Freescale Semiconductor, Inc.
Board Errata

Document Number: FRDMK64F_ERRATA
Rev. 2.0, 06/2014

FRDM-K64F Board Errata

Figure 1. Swapped I²C signals Pin18 and on J2

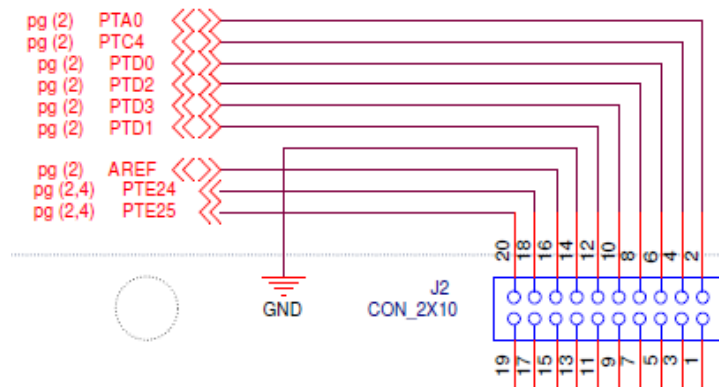
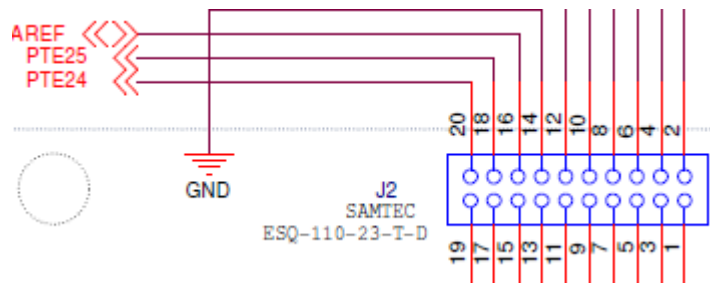
1 Errata Title: I²C signals are swapped on I/O headers

Description: Pin 18 (I2C0_SCL) and pin 20 (I2C0_SDA) of J2 I/O Header, and pin 10 (I2C_SCL) and pin 12 (I2C0_SDA) of J4 I/O Header are swapped. [Figure 1](#) and [Figure 2](#) show the incorrect signals.

The correct position should be:

1. Use jumper wires to connect between Arduino compatible shield signals to the FRDM board I/O header signals. Swap the jumper wires only on the I²C signals.
2. When pin 10 of J4 (PTC10) and pin 12 of J4 (PTC11) are not used on the shield, route pin 10 of J4 to pin 20 of J2 and pin 12 of J4 to pin 18 of J2. Configure PTE24 and PTE26 (pin 18 and pin 20 of J2) as GPIO, and use PTC10 and PTC11 (pin 10 and pin 12 of J4) as I²C signals.

Fix Plan: Fixed in FRDM-K64F board (700 Assembly Rev B, Schematic Rev D1).

Figure 5. Correct order of I²C signals on J2

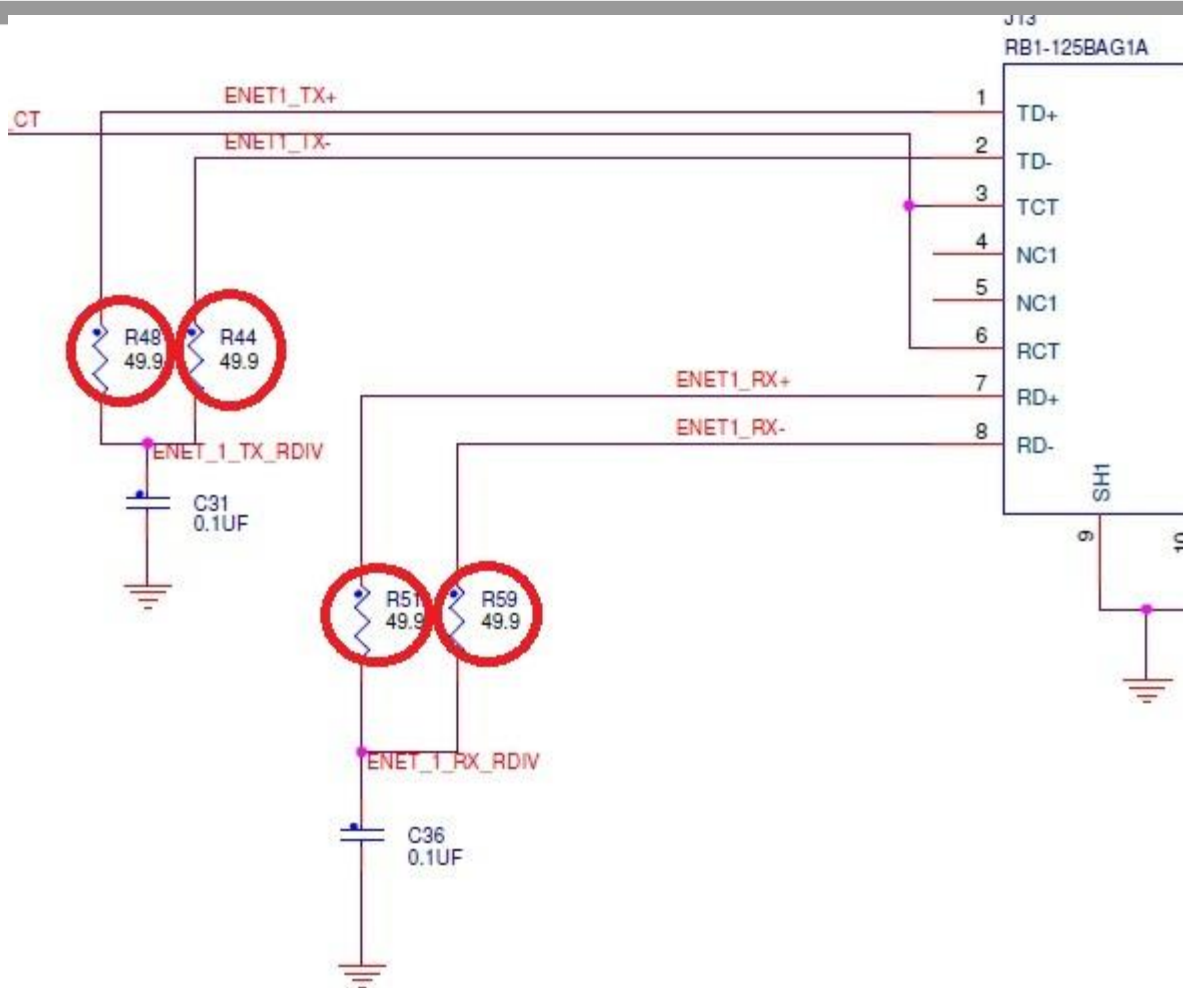
Description: When two FRDM-K64F boards are connected together with an Ethernet cable, the Ethernet PHY can't establish the link status, and will drop to a default state of 10Mbit and half duplex mode. This is caused by incorrect termination on the TD+ and RD+ signals, which reduces the link signal detection. This issue does not affect other connections such as PC host to FRDM-K64F, TWR-SER1/2 to FRDM-K64F, or network switch to FRDM-K64F when the cable length is less than 25 feet. This issue affects both Rev C and Rev D1 boards.

Workaround: Remove the four resistors R44, R48, R51, and R59 that connect to TD+, TD-, RD+ and RD- signals.

Fix Plan: A fix has been planned for future version of FRDM-K64F board (after 700 Assembly Rev B, Schematic Rev D1).
